REGIONAL REVIEW FINDING

ARC REVIEW CODE: R809301

Submitting Local Government: City of Atlanta
Name of Proposal: 777 Memorial Drive

Preliminary Report:	September 30, 2008	DEVELOPMENT OF REGIONAL IMPACT REVIEW REPORT	Project:	777 Memorial #1909
Final Report Due:	October 30, 2008		Comments Due By:	October 14, 2008

A1.0

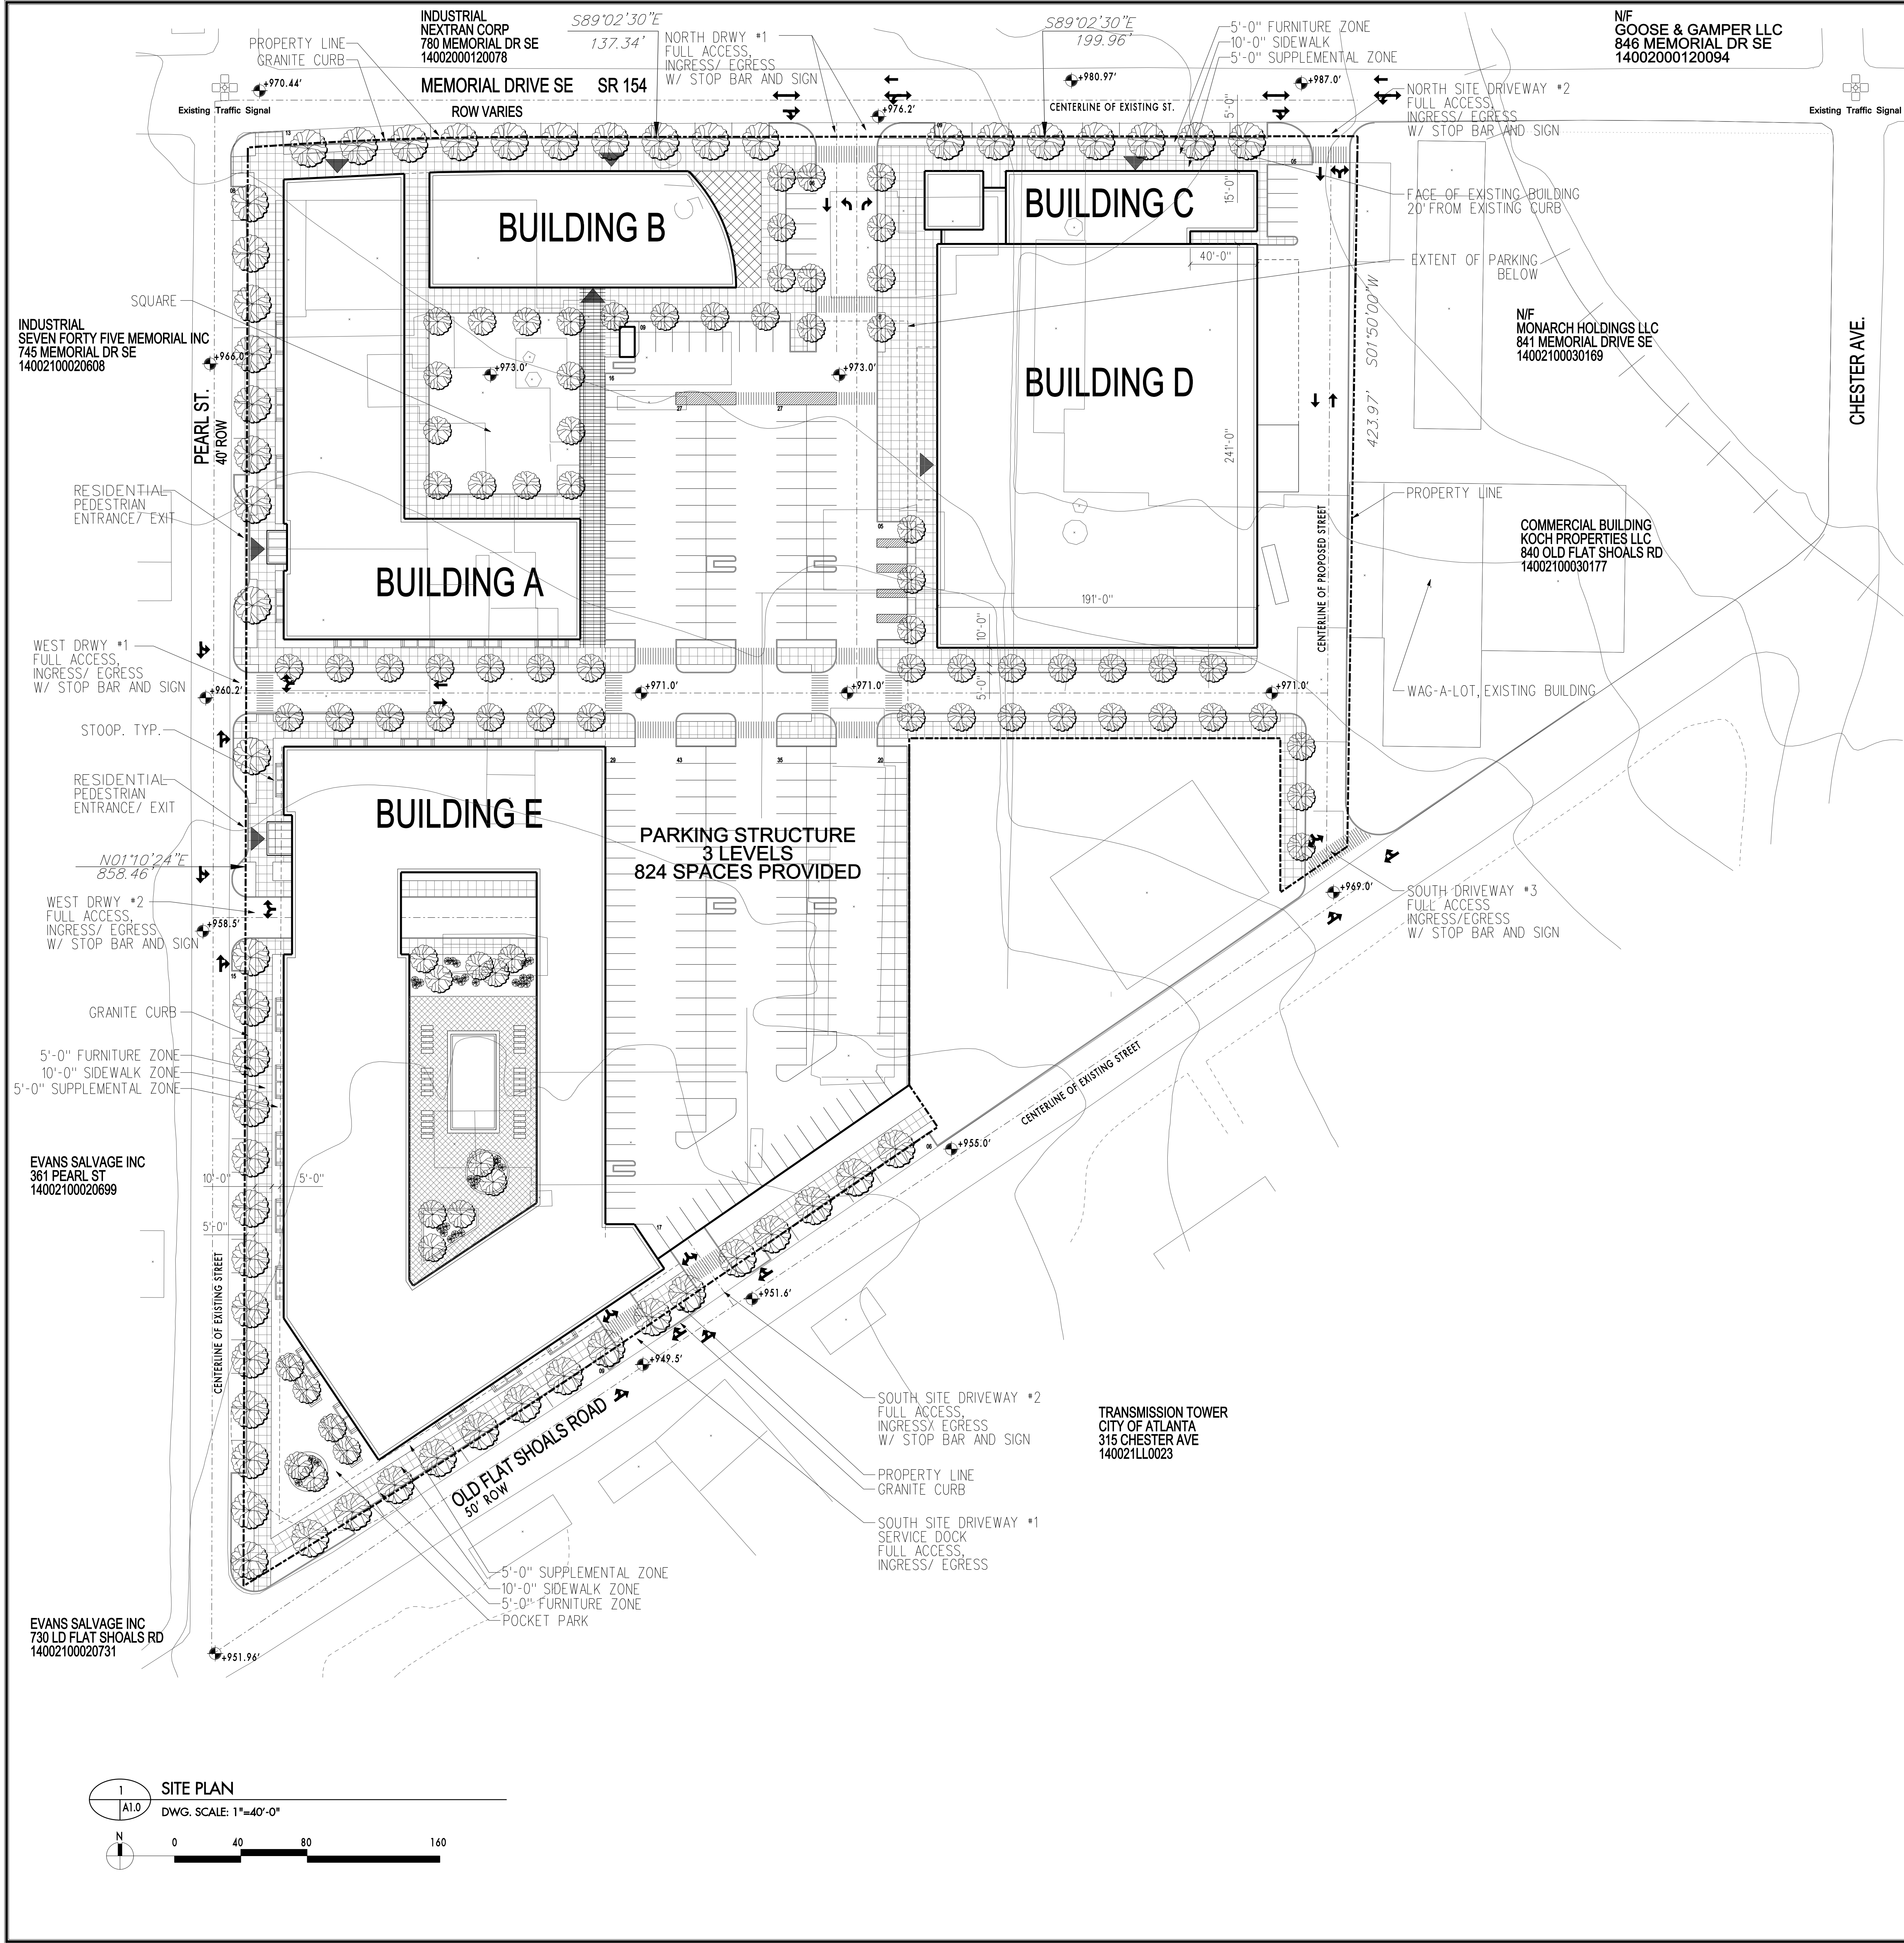
- The two full-access driveways proposed on Memorial Drive are in close proximity to each other, and the nearest public roadways (Pearl Street and Chester Avenue). ARC is concerned with the proximity and will examine the issue in closer detail during the remainder of the review period.
